Contract #: 04-0120F4Cty: SF/ALA Rte: 80 PM: 13.2/13.9File #: 69.25B**QUALITY ASSURANCE -- NON-CONFORMANCE REPORT****Location:** Changxing Island, Shanghai, P.R. China**Report No:** NCR-000374**Prime Contractor:** American Bridge/Fluor Enterprises, a JV**Date:** 30-Jul-2009**Submitting Contractor:** Zhenhua Port Machinery Company, Ltd (ZPMC), Changxing Island**NCR #:** ZPMC-0348**Type of problem:**

Reference Description: Missed UT indications by QC on Traveler Rail Bracket TR1E**Description of Non-Conformance:**

Job Name: SAS Superstructure

Subject: NCR No. ZPMC-0348

WELD NUMBER:TR1E-PP28-009

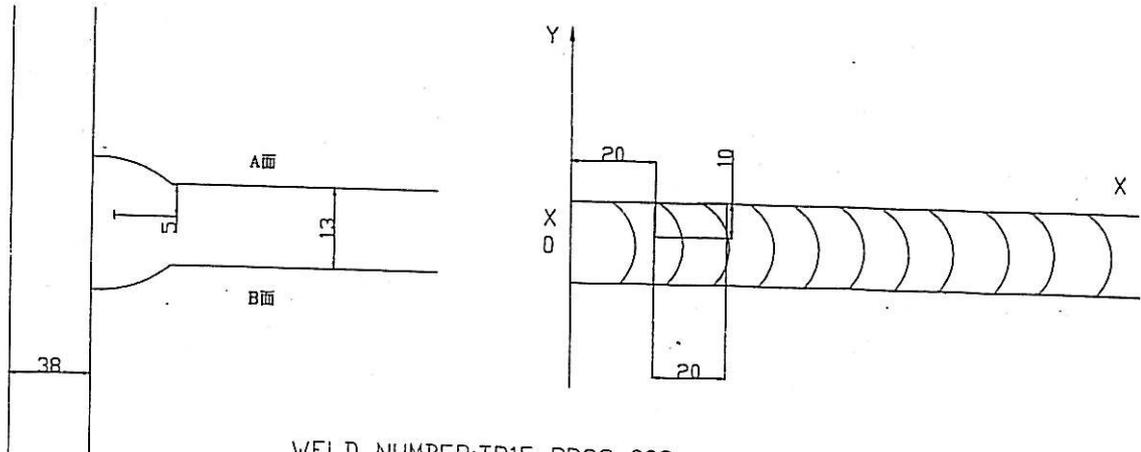
焊缝缺陷描述:

Description of welding discontinuity:

Rejected indication found by ultrasonic inspection is less than the maximum allowance aggregate length.

(UT探伤发现的缺陷总长度小于最大允许长度。) TR1E-PP28-009

1. 从缺陷距离端面较近一侧 ($D \leq 0.65T$, D 为缺陷深度, T 为板厚) 采用碳刨或打磨的方法去除焊缝缺陷;
 2. 参照返修焊接工艺规程 (WPS) 准备正确的接头型式, 预热和焊接;
 3. 焊前对修补区域进行VT检测保证缺陷完全被清除;
 4. 将修补区域打磨到与母材或邻近焊缝平齐;
 5. 根据批准的车间图纸检查焊缝.
-
1. Gouge or grind from nearer side from metal edge ($D \leq 0.65T$, " D " is depth of defects, " T " is thickness of metal) to remove all defects;
 2. Follow repair WPS for joint preparation, preheat, and weld deposit;
 3. Verify with VT no defects remain in the weld joint prior to welding;
 4. Grind the repaired area flush with base metal or the adjacent weld;
 5. Check the welds according to the working drawings.
